Proposed Corriegarth 2 Wind Farm: Response to SEPA Consultation Request

Appendix A – Amended Figures

Corriegarth 2 Wind Farm

Figure 7.2

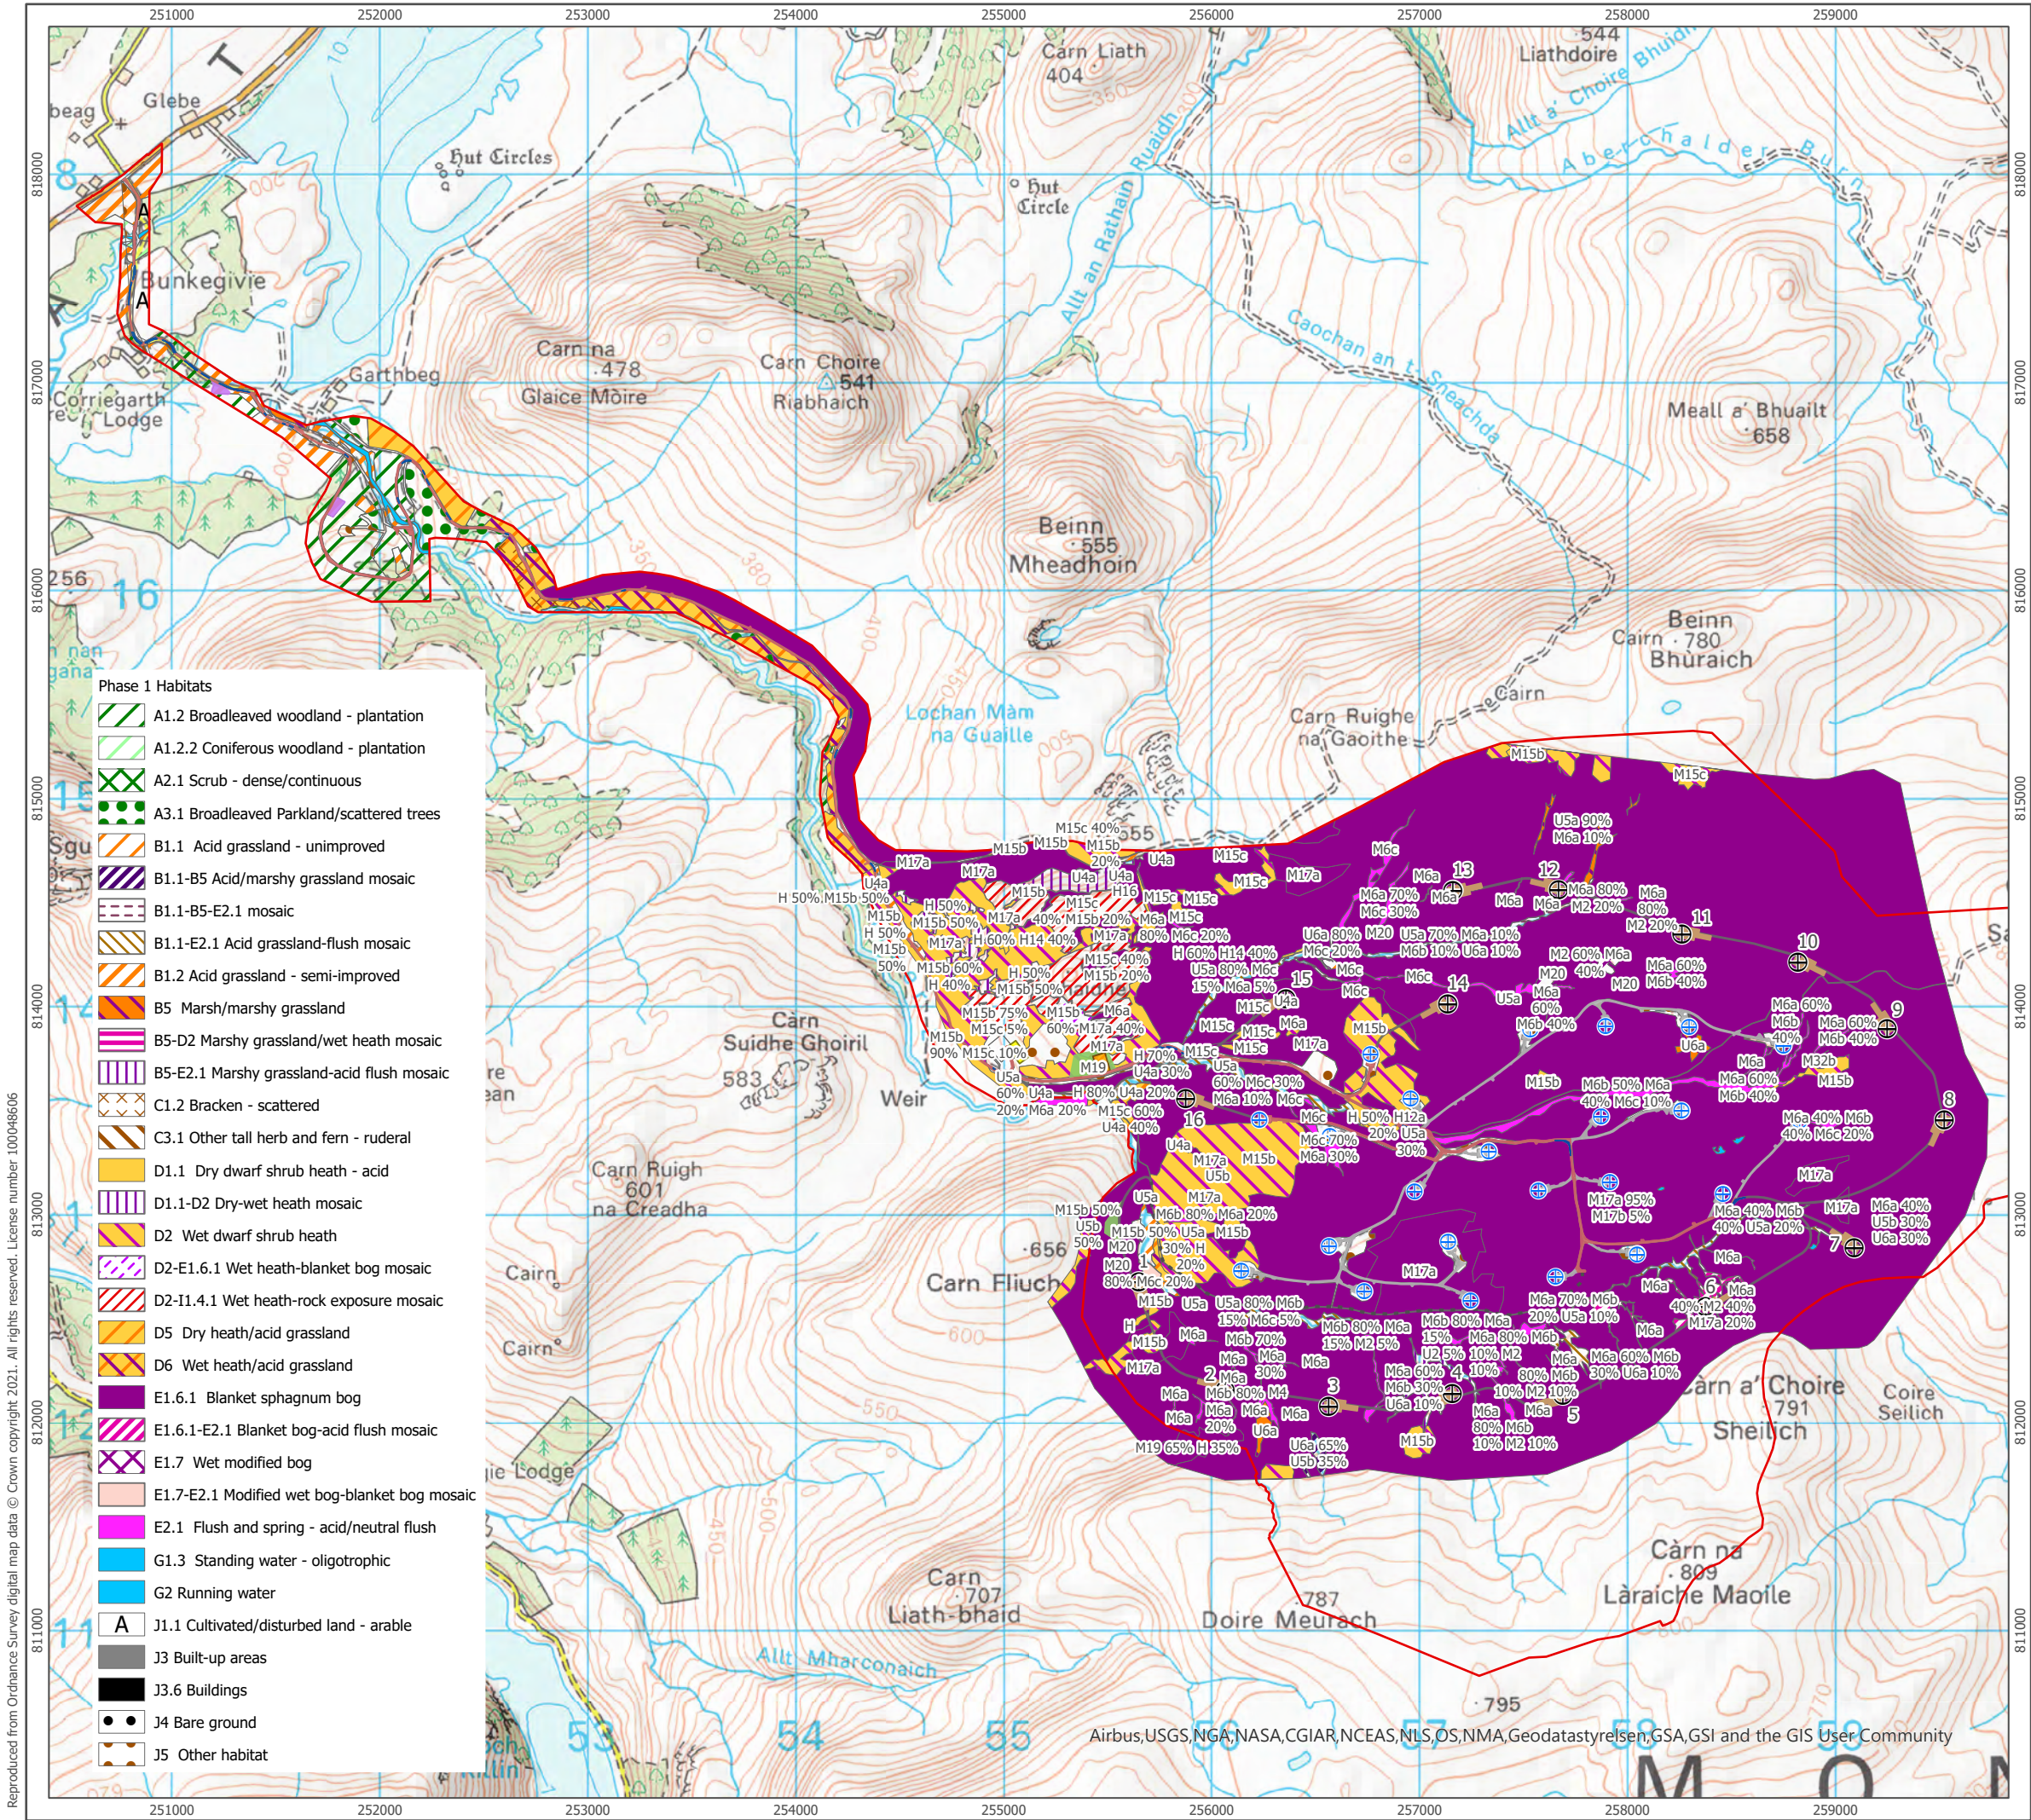
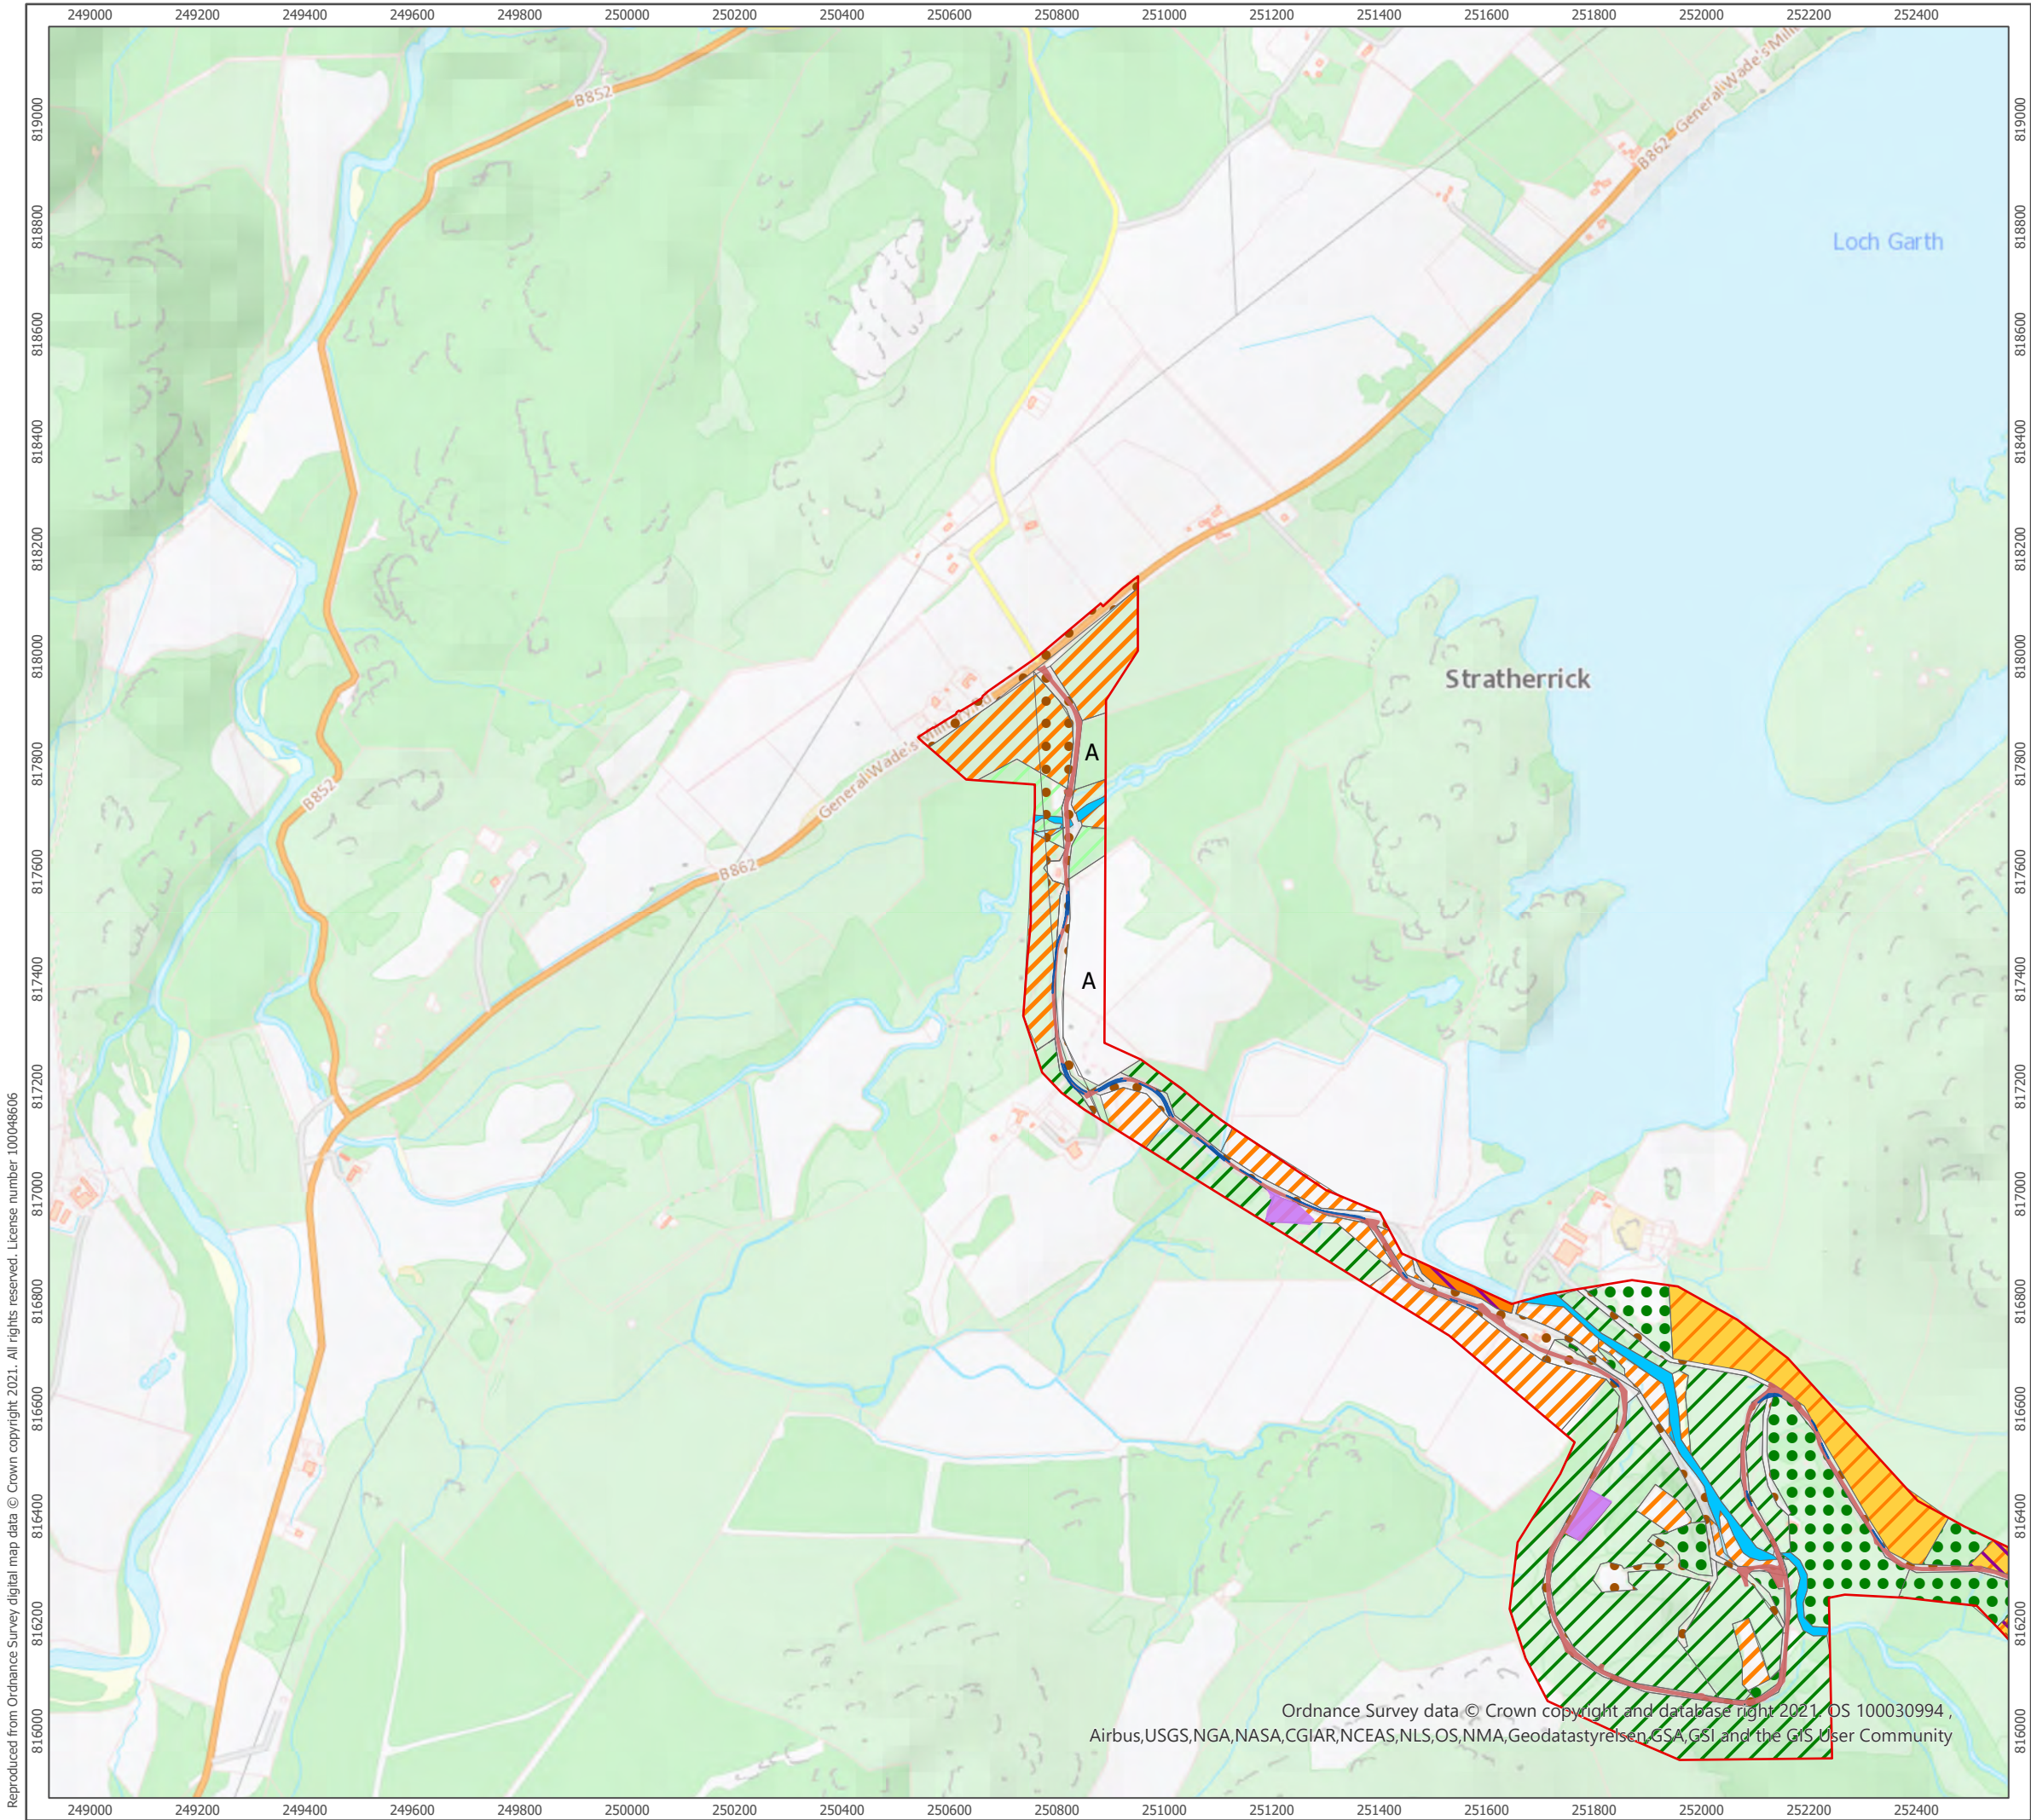
1. Figure 7.2 of Chapter 7: Ecology of the EIA Report is amended to include all proposed infrastructure associated with the Development (clearly marked);
2. All of the figures contained within Technical Appendix A7.1: Habitats and Botany Surveys to include all proposed infrastructure associated with the Development (clearly marked); and
3. Figure 13.2.2 of Technical Appendix A13.2: Outline Peat Management Plan to be provided on OS Basemapping; to be provided in a map series format; and with a revised symbology colour ramp.

SEPA Amendment Request¹	Applicant Response
1.	Arcus Consultancy Services Ltd ('Arcus'), on behalf of Corriegarth 2 Wind Farm Limited ('the Applicant'), have added all proposed new infrastructure associated with the Development to Figure 7.2. The added infrastructure associated with the Development is clearly marked via the legend. Due to the number of entries in the legend, the text and indicative symbol boxes have had to be reduced; however, it is considered that all information remains clear. Figure 7.2 also includes the NVC labels, as requested by SEPA through further discussion with Arcus (via telephone 06/07/2021). Figure 7.2 now also includes an overview figure for ease.
